October 18, 2013

**Subject: Bingham Wind Project, Response to Environmental Project Review Comments from
Maine Department of Inland Fisheries and Wildlife
Project # L-25973-24-A-N / L-25973-TG-B-N**

BIGELOW BROOK

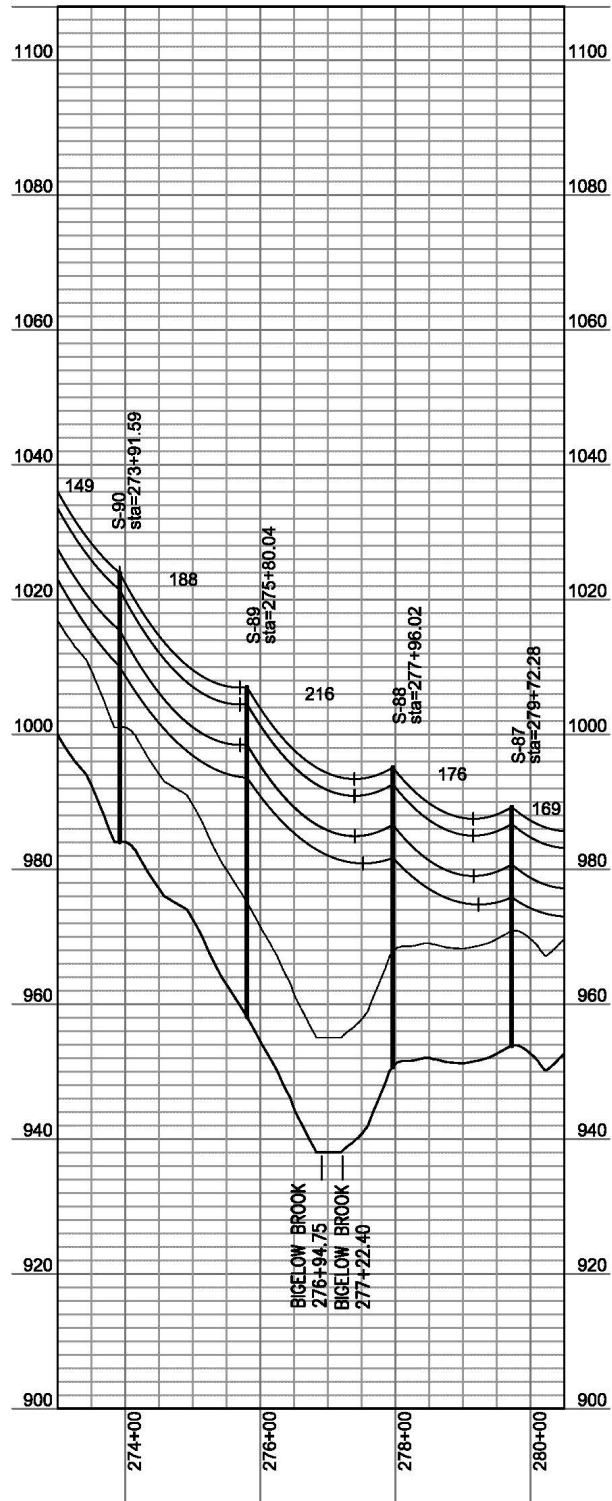
Vegetative clearing at these stream crossings may result in thermal impacts to these reaches. While vegetative buffers will be allowed to regrow, these buffers will be ineffective at the wider stream crossings, particularly with the maintenance (removal) of capable species. How does the applicant propose to address this issue?

Bigelow Brook — The collector line will cross Bigelow Brook approximately 185 feet northwest of the Route 16 crossing. A steep bank on the west side of the stream should help increase conductor height over the stream and reduce the number of trees that will need to be topped.

An approximately 42-foot-tall canopy will be retained within 25-feet on either side of the stream.
